CONTRACT DOCUMENTS
Reedy River Basin Sewer Tunnel

ADDENDUM III - CONTRACT REVISIONS

B&V Project No. 192263

September 22, 2017

CONCRETE ENCASEMENT DETAIL C
 NO SCALE

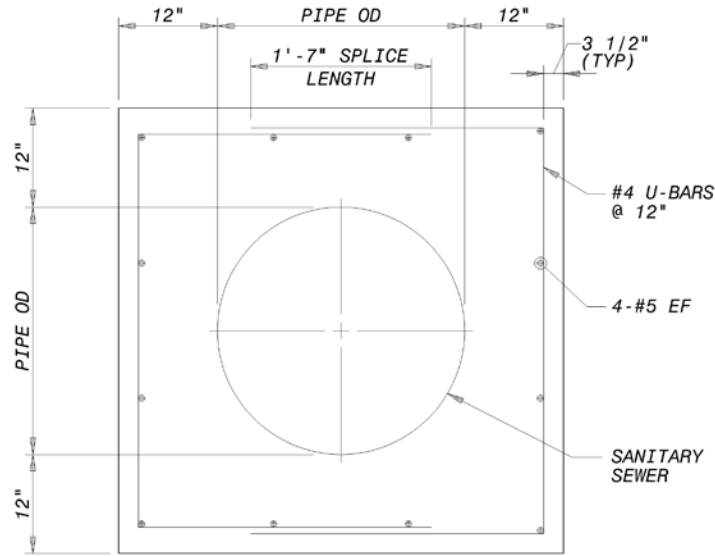
10. Drawing C19 – Miscellaneous Details (4 of 4). Detail A/C19. Rename callout bubble for RIP RAP from “A/-” to “D/-”. Rename callout for STONE RIP-RAP DETAIL from “A” to “D”.

Add the following detail as new “Detail C”:

1. USE 3000 PSI CONCRETE.
2. CONCRETE ENCASEMENT SHALL EXTEND A MIN OF 10 FEET EACH SIDE OF TRANSMISSION MAIN OR TO NEAREST MANHOLE. BEGIN AND END ENCASEMENT AT SEWER JOINT.
